SCI-823-0.00
PID Nos. 19415, 77366, 79977

Value Engineering Study Report
Draft Stage 2 Design Phase

re: SCI-823-0.00, PID Nos. 19415, 77366 and 79977, Portsmouth Bypass
Harrison, Jefferson, Madison and Porter Townships, Scioto County
Value Engineering Study Report

TRANSVERSE SECTION
 BRIDGE NO. SCI-823-1357 L&R
 S.R. 823 OVER MORRIS LANE BLUE RUN (C.R. 54)

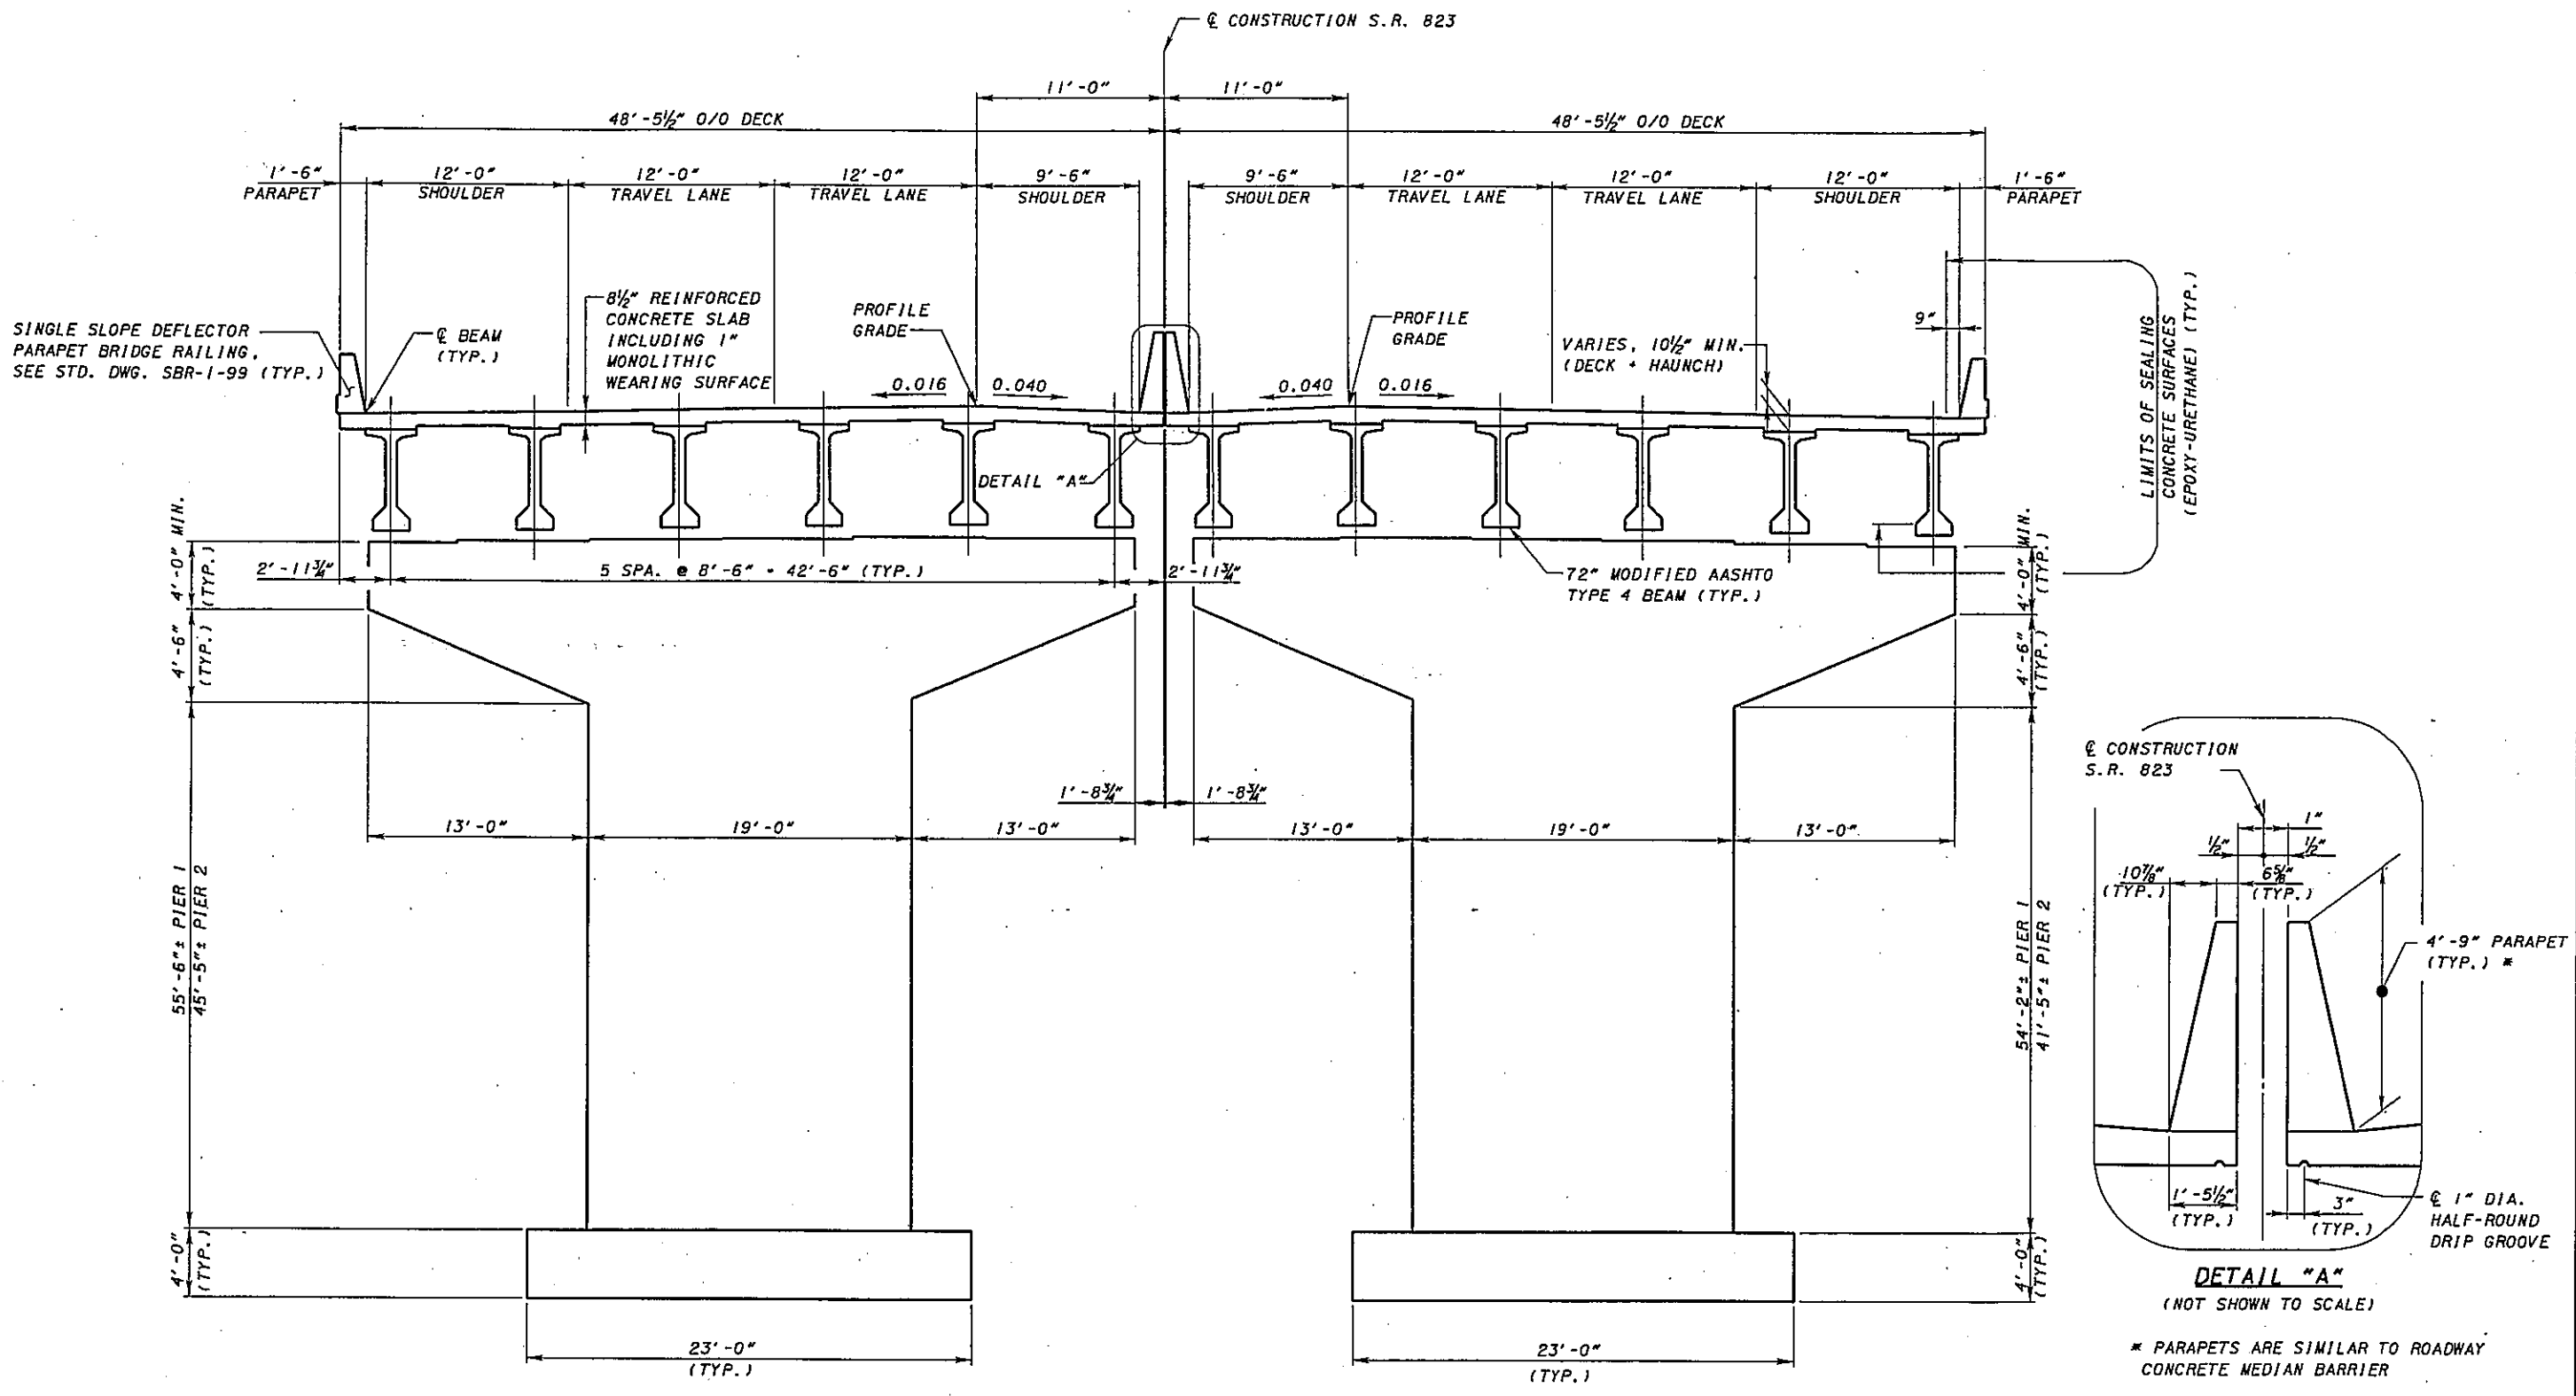
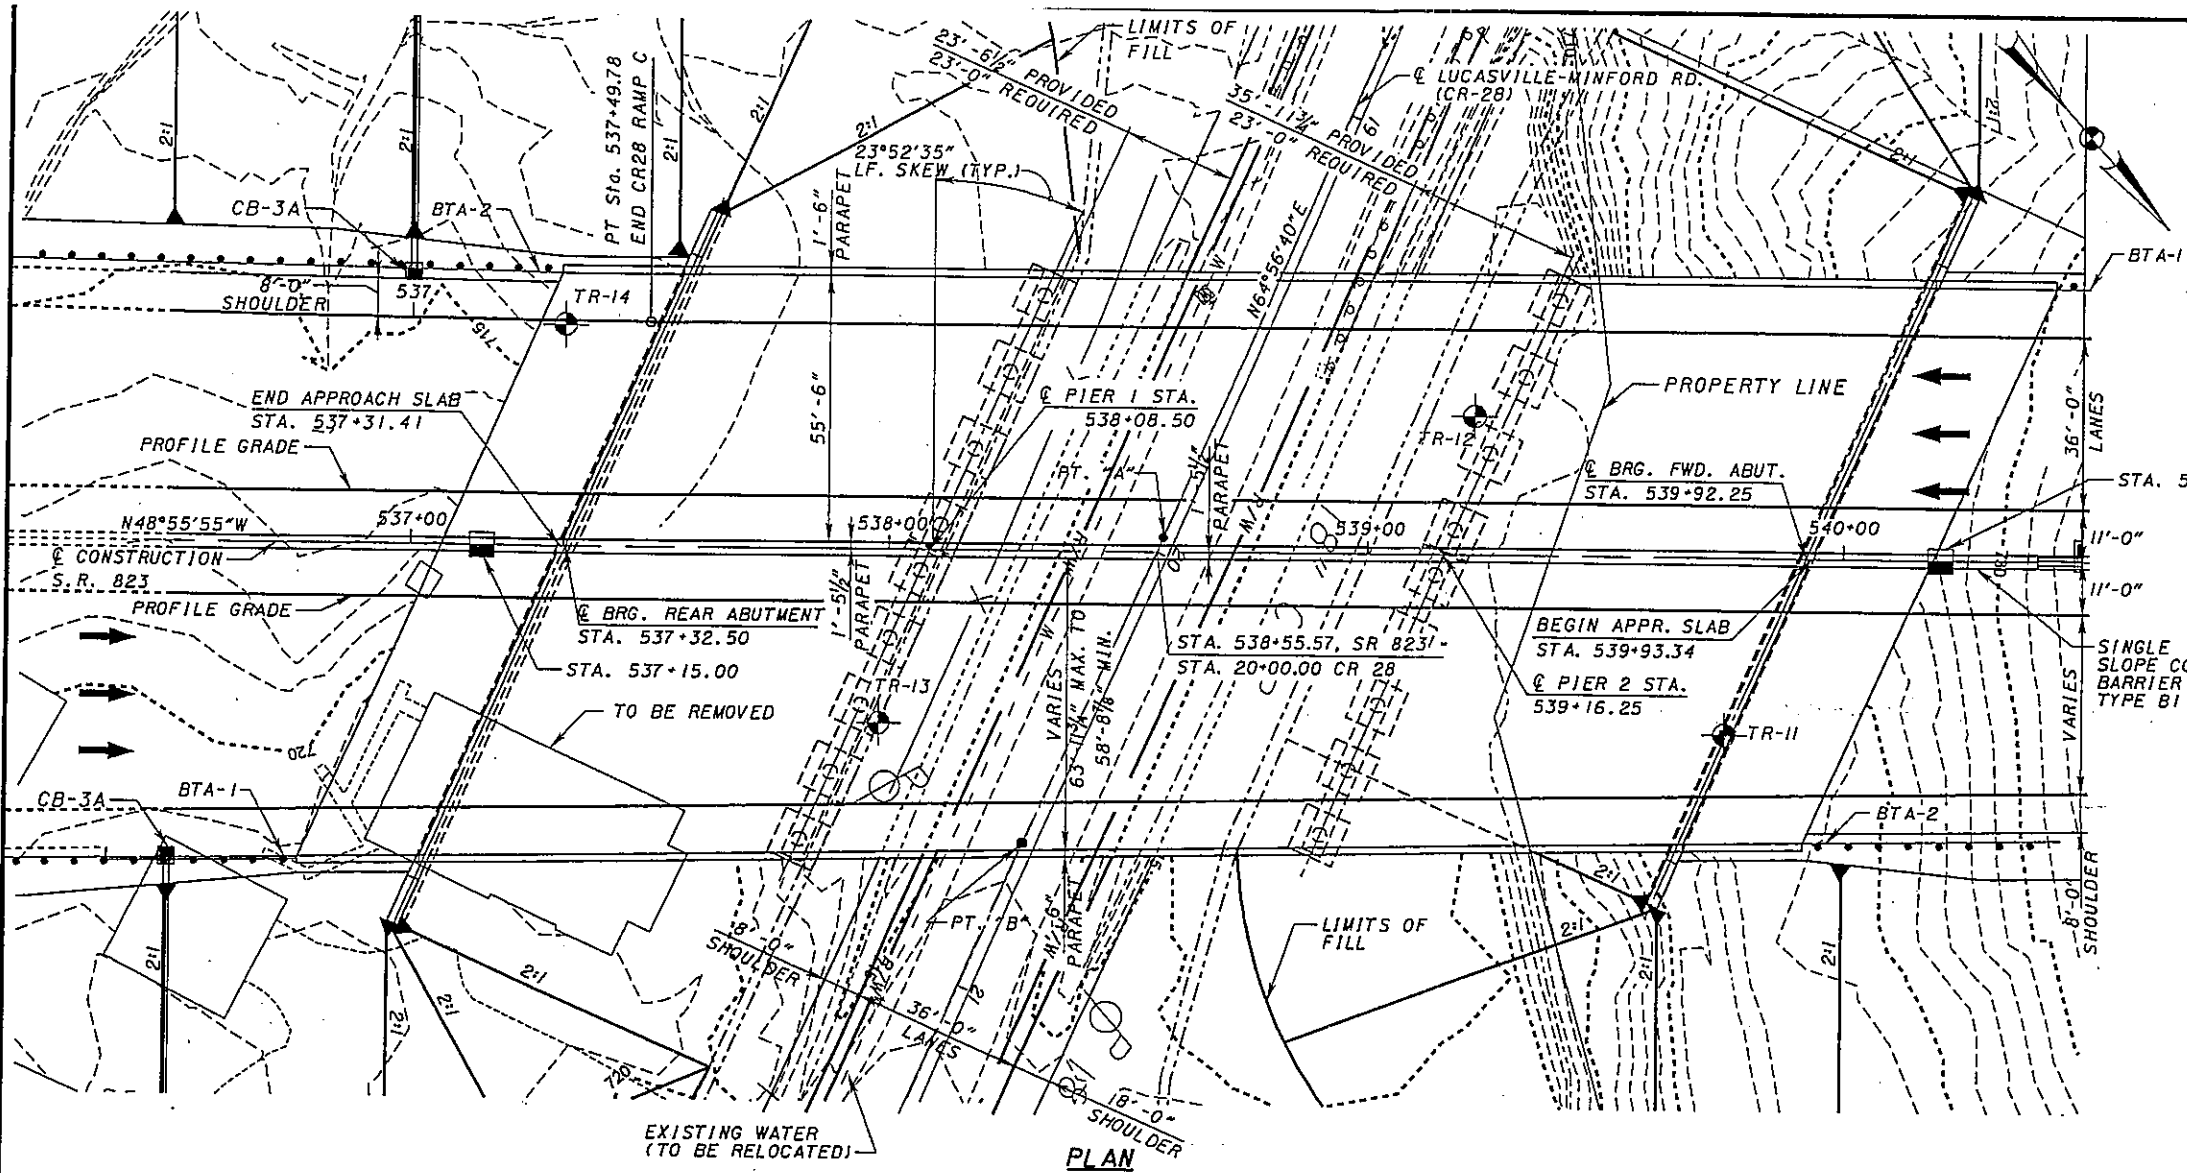
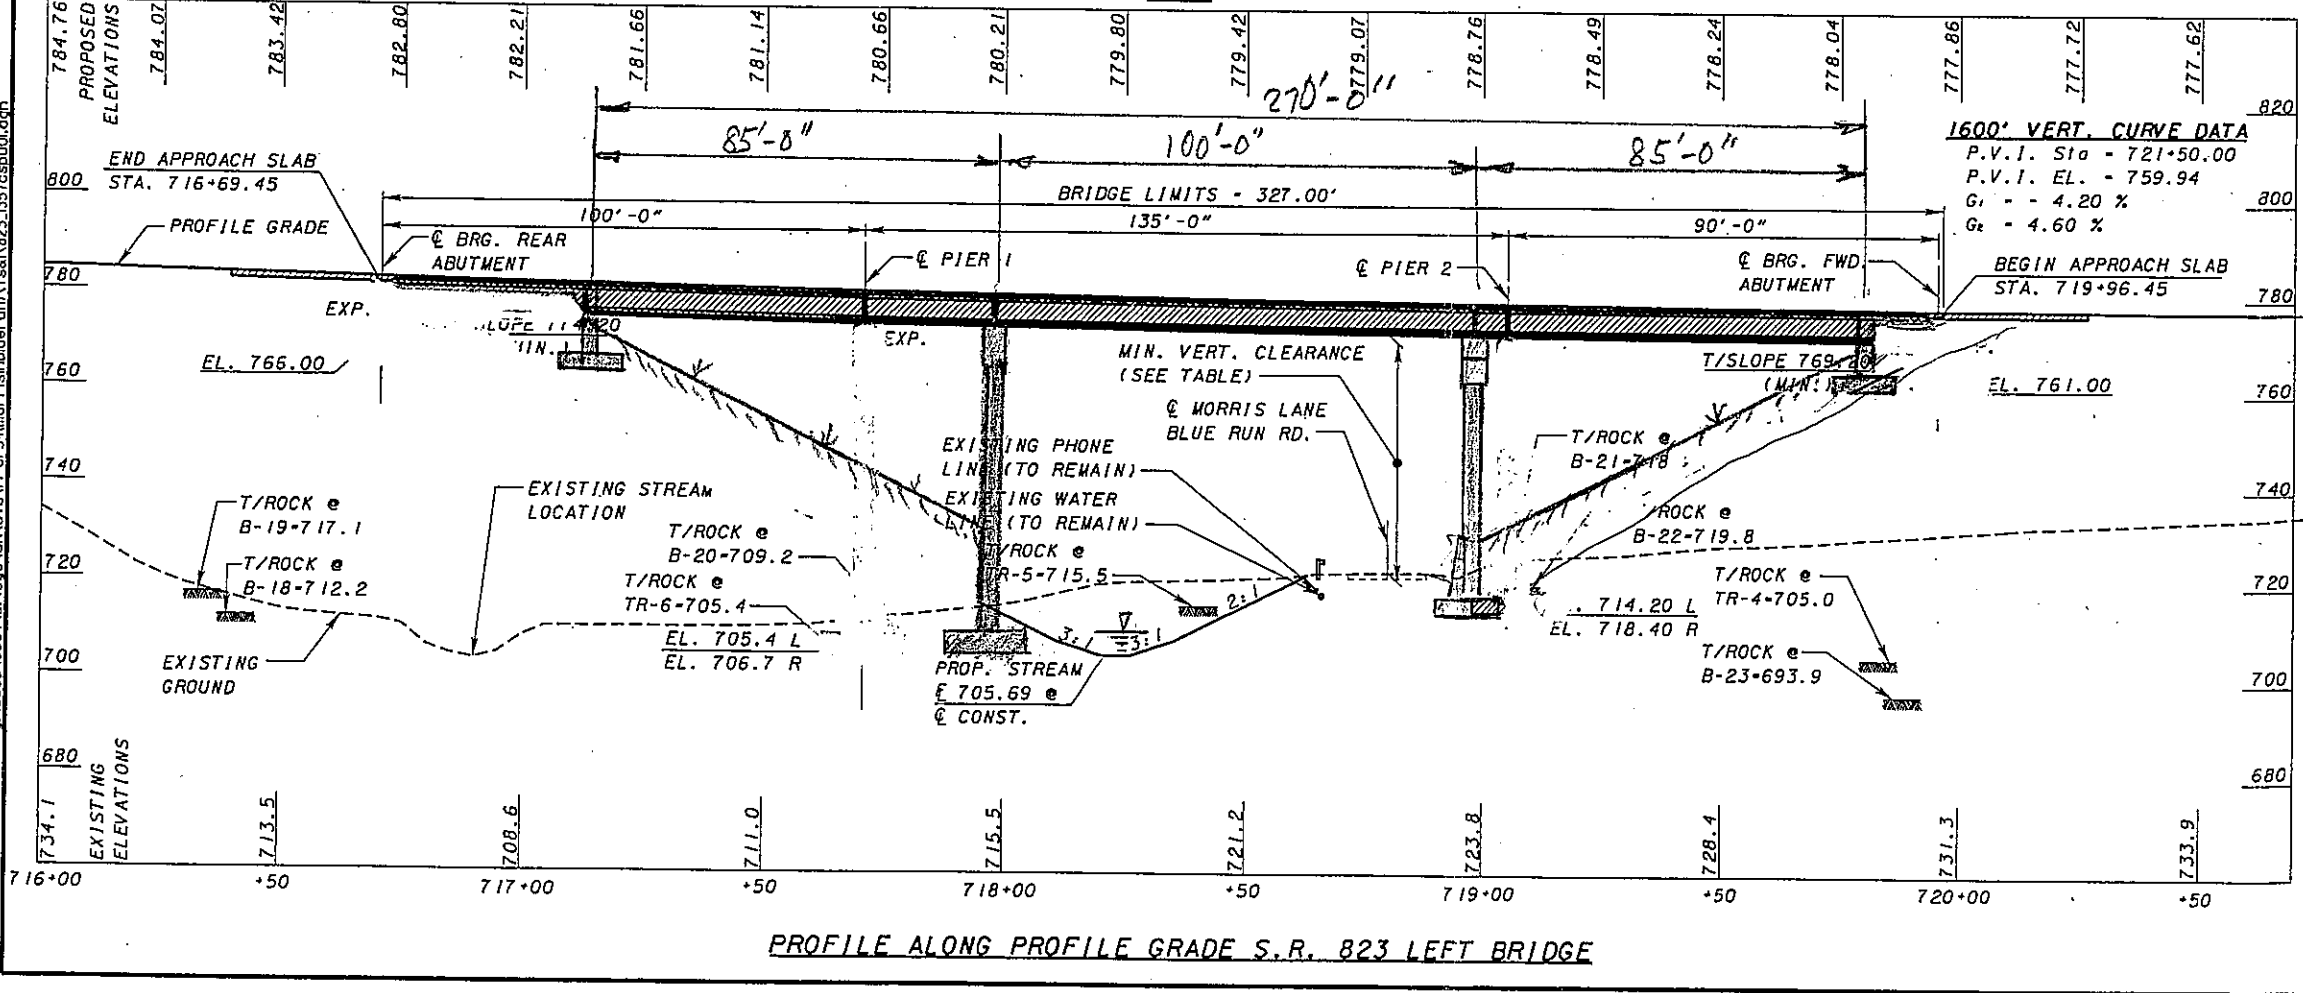
- SCI-823-1018 L&R – Site Plan
- SCI-823-1018 L&R – Pier Details
- SCI-823-1357 L&R – Site Plan
- SCI-823-1357 L&R – Pier Details

- Revised SCI-823-1018 L&R – Site Plan
- Revised SCI-823-1018 L&R – Pier Details
- Revised SCI-823-1357 L&R – Site Plan
- Revised SCI-823-1357 L&R – Pier Details
